Technical documentation rif.06.02

Object: New front and rear shock absorber

Model: Murciélago MY02

The replaced shock absorber must have always the same Koni code as the mounted one. picture nr.1

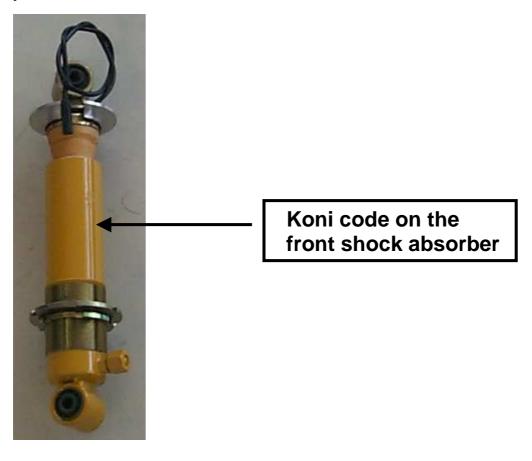
To avoid any misunderstanding you must absolutely confront the Koni codes (see pictures nr.1 and nr.2) stamped on the shock absorber body.

Do not fit on the same vehicle shock absorbers with different specifications.
